# Access Compliance Report

## Public Rights-of-Way

### (Curb Ramps)

Intersection ID: 11898	Main Street: ALLEN_ST	Cross Street: E_18TH_ST	Location: W
ADA ID: 1567D6BCB298	Ramp Type: Directional1	Initial Pass/Fail: Fail	Overall Compliance: No
		Severity Score: 1.25

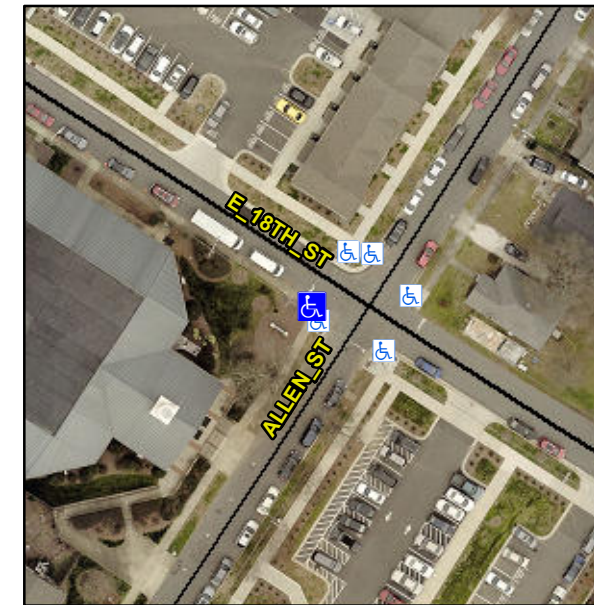
**R304.5.3**

Compliance	Description	Data	Compliance	Description	Data
N/A	Ramp Length (in)	56.5	N/A	Grade Break?	N/A
Yes	Ramp Width (in)	57.0	N/A	Grade Break Slope (%)	0.0
Yes	Ramp Slope (%)	6.6	N/A	Grade Break XSlope (%)	0.0
No	Ramp XSlope (%)	3.3			
N/A	Flare Type LT	N/A	N/A	Flare Type RT	N/A
N/A	Flare Slope LT (%)	N/A	N/A	Flare Slope RT (%)	0.0
N/A	Flare Traversable LT?	N/A	N/A	Flare Traversable RT?	N/A
N/A	Landing Length (in)	0.0	N/A	DWS Provided?	N/A
N/A	Landing Width (in)	0.0	N/A	DWS Contrast?	N/A
N/A	Landing Slope (%)	0.0	N/A	DWS Length (in)	N/A
N/A	Landing X Slope (%)	0.0	N/A	DWS Full Width?	N/A
N/A	Landing Curb? (Y/N)	N/A	N/A	DWS Offset LT (in)	N/A
N/A	Shared Landing?	N/A	N/A	DWS Offset RT (in)	N/A
N/A	Gutter Ponding?	0.0	N/A	Gutter Slope (%)	N/A
N/A	Gutter Lip Ht (in)	0.0	N/A	Gutter X Slope (%)	N/A
N/A	Painted X Walk1?	No		Road Slope (%)	2.7
	X Walk 1 Direction	To NE		Road X Slope (%)	2.1
	X Walk 1 Width (in)	N/A		Clear Space?	N/A

**Remove & Replace Entire Ramp.**
